Re: Belews Creek Steam Station FGD Landfill
NCDENR Permit # 85-05
Leachate System Modification

The purpose of this letter is to transmit a revised leachate system drawing for the FGD Landfill (NCDENR Permit #85-05) at the Belews Creek Steam Station in Walnut Cove, NC. As we discussed by telephone last week, Duke desires to modify the leachate system to keep all four of the leachate drain lines open (rather than closing three of them as prescribed in the original design). The attached drawing (OP-5) is the only drawing affected. In addition, we have conducted a review of the Operations Plan and determined that no revision is necessary.

**BELEWS CREEK STEAM STATION
FGD RESIDUE LANDFILL**

REVISIONS	
1	3/19/12 Rev. penetration abandonment notes
0	4/18/06 Issued for CPA
PROJECT #: 046119 DATE: 4/18/06	
DRAWN BY: DC CHECKED BY: DB	
TITLE	
Cell Operations - Leachate Collection And Removal System	
SHEET	OP-5

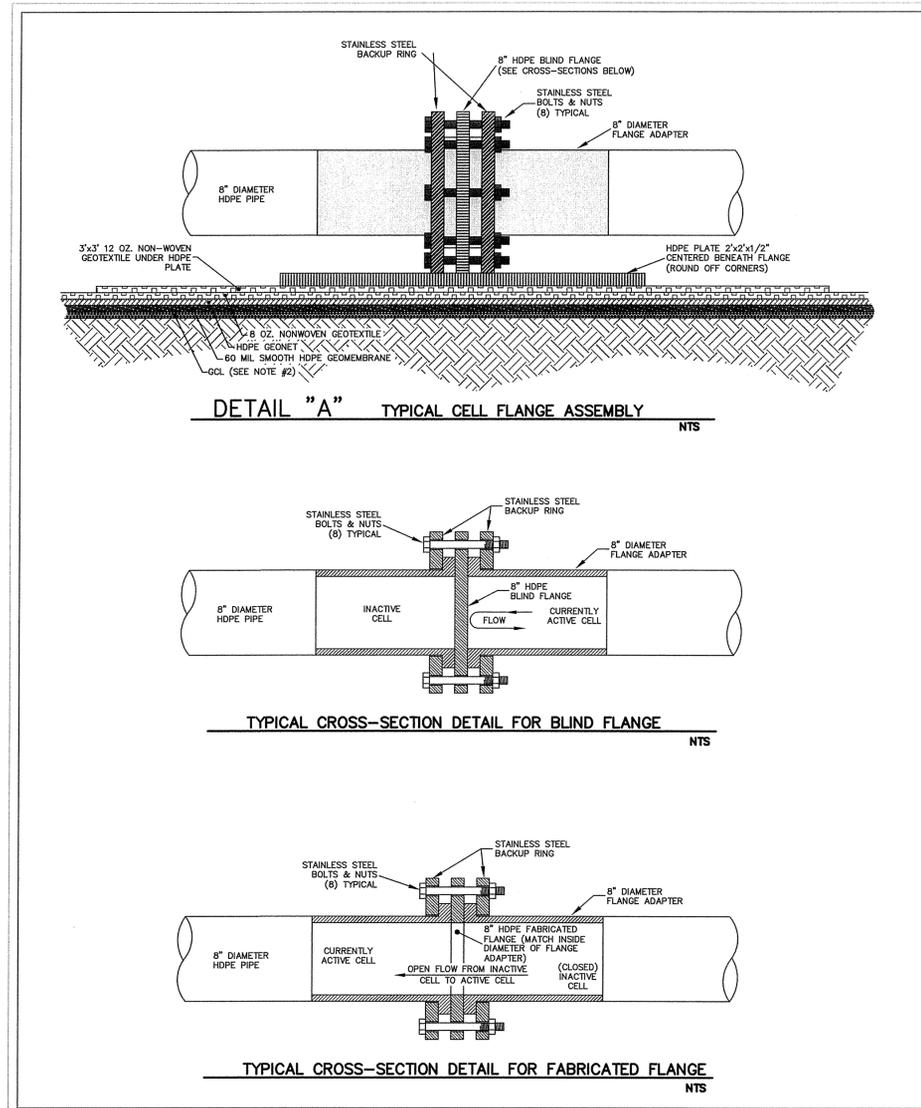
- 1) Ensure gate valve at end of CV-21 is in Open position.
- 2) Abandon CV-13 by grouting 5' from upstream end; install 60 mil HDPE patch over inlet.
- 3) Remove 8" dia. Blind Flange at Cell 4 Flange Assembly and replace with fabricated 8" HDPE flange (modified to match inside diameter of 8" SDR 17 HDPE pipe). Replace #57 stone and geotextile over flange assembly.
- 4) Convert Cell 3 Active Leachate Collection Sump to Inactive Leachate Collection Sump.
- 5) Prior to placement of waste over Cell 4 Leachate Sump, convert to Inactive Leachate Collection Sump.

Instructions for Abandonment of Culvert CV-13.

- 1) Cut barrel of pipe at 12 inches from Leachate Sump Riser.
- 2) Install HDPE pipe cap on 12-inch stub to Leachate Sump Riser by double-butt fusion welding.

- 3) Cut and remove HDPE boot around barrel of pipe to expose concrete collar around barrel.
- 4) Cut HDPE pipe at or below concrete surface. Grind end of pipe flush with concrete surface.

- 5) Grout first 5 ft. of barrel.
- 6) Install stitch reinforced GCL (Bentomat DN or equivalent) patch over grouted pipe and concrete collar. Place a layer of granular bentonite over concrete collar and grouted pipe prior to installation of GCL patch.

- 7) Ensure a minimum of 12-inch overlap between GCL patch and the existing GCL on the side slope.
- 8) Install 60 mil textured HDPE patch over GCL patch. Patch must be circular and provide a minimum of 6-inch overlap to existing HDPE geomembrane.

- 9) HDPE patch should be installed and tested in accordance with Technical Specification Section 4.3.7.
- 10) Prepare report documenting process and retain in operating record.
